Westinghouse Advanced Doped Pellet Technology (ADOPT™) Fuel

WCAP-18482-NP-A
Revision 0

September 2022

<u>Section</u>	<u>Description</u>
A	Final Safety Evaluation Letter from Richard Chang (USNRC) to Camille Zozula (Westinghouse), “Final Safety Evaluation for Westinghouse Electric Company Topical Report WCAP-18482-P/WCAP-18482-NP, Revision 0, “Westinghouse Advanced Doped Pellet Technology (ADOPT™) Fuel” (EPID: L-2020-TOP-0025)
B	List of Changes
C	Submittal of Topical Report LTR-NRC-20-33, Letter from Korey L. Hosack (Westinghouse) to USNRC, “Submittal of WCAP-18482-P/WCAP-18482-NP, ‘Westinghouse Advanced Doped Pellet Technology (ADOPT™) Fuel,’ Revision 0 (Proprietary/Non-Proprietary),” May 8, 2020.
D	Submittal of Responses to Request for Additional Information #1 LTR-NRC-21-9, Letter from Zachary S. Harper (Westinghouse) to USNRC, “Responses to NRC Request for Additional Information for Westinghouse Topical Report WCAP-18482-P/WCAP-18482-NP, Revision 0, ‘Westinghouse Advanced Doped Pellet Technology (ADOPT™) Fuel’,” March 19, 2021.

Figure 6-15: Macrograph of 1000ppm Cr₂O₃ pellet post ramp. Etched condition.

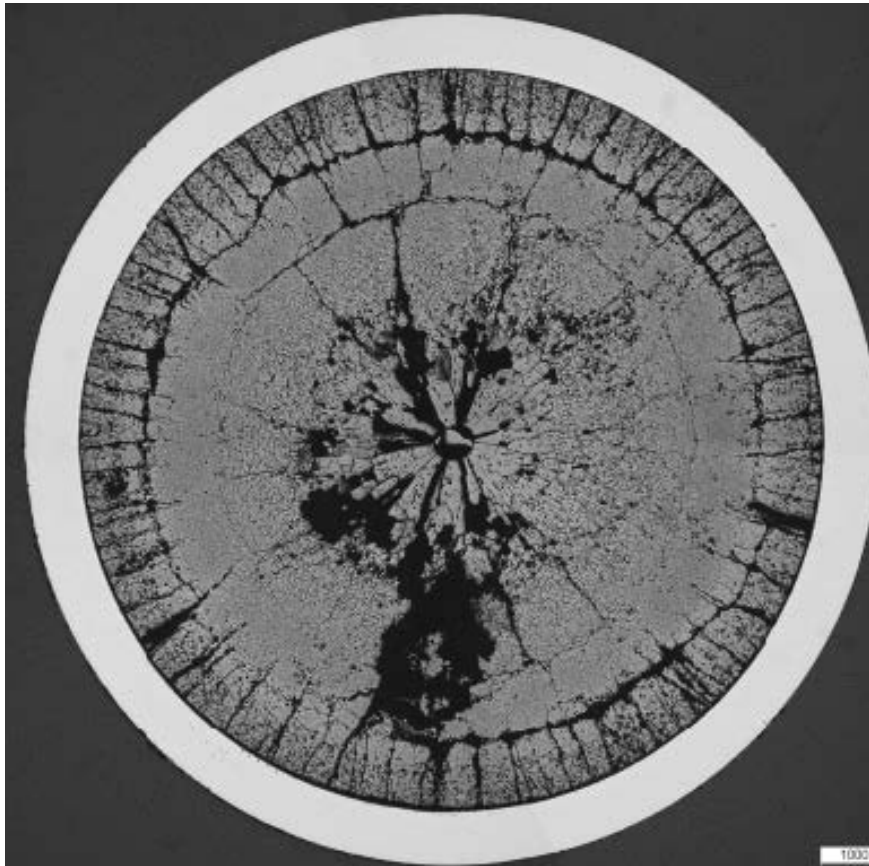
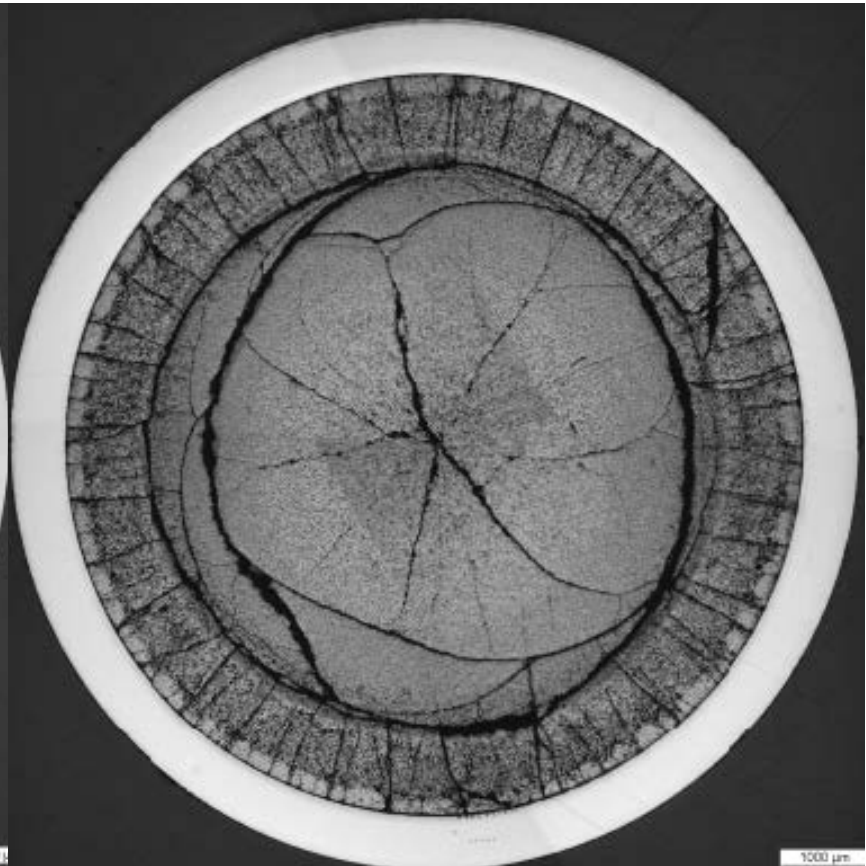
Ceramography of the ramp segment 33004 with 1000 ppm Cr_2O_3 revealed a central void, unlike the standard pellet from segment 33002. The void appeared in the region of the segment which had been subjected to the highest powers. The additives enhance the pellet's viscoplasticity at these high temperatures, filling the pellet's dished area during power ramp test. Small radial cracks are observed at the periphery in both pellet types; however, the rim structure is smaller in the doped pellet, see *Figure 6-15* and *Figure 6-16*.

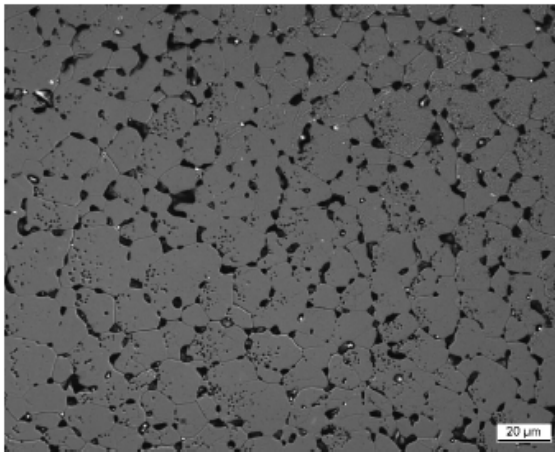
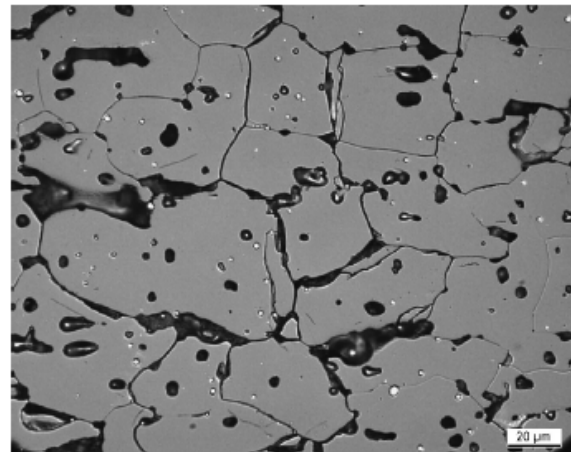
The volume change of the UO₂ and **ADOPT** fuel from the Barseback-Studsvik test at power level of 57 kW/m are shown in Figure 4-6 of the **ADOPT** topical report. The cladding diameter change for the same two rods are shown in Figure 11-1 for **ADOPT** fuel and Figure 11-2 for UO₂ fuel. [

] ^{a,c} The result for other two rods from the same test at a lower power level (45 kW/m) are shown in Figure 11-3 for **ADOPT** fuel and Figure 11-4 for UO₂ fuel, where [
